C-6200 with line cards

What are the correct locations for J9 and J18 on the Dual Tone line cards?

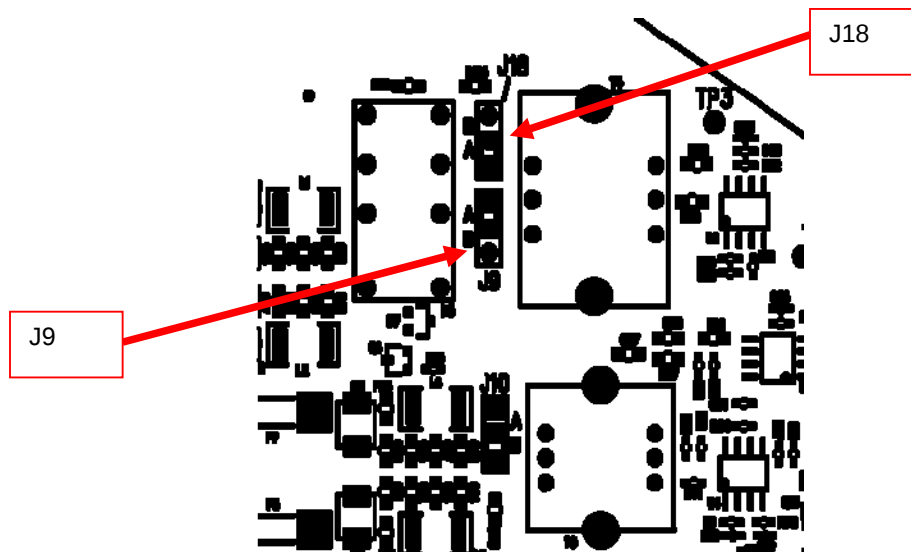
While all manual versions have correctly described jumper configuration for Line 1 TX path J9 and J18, early versions of the PCB (P/N 750597, A through E) had silkscreen that incorrectly labeled J9 and J18.

Changes to J9 were in actuality being done to J18 and vice versa, the latest PCB revision F has the silkscreen correctly located as shown in the silkscreen picture below.
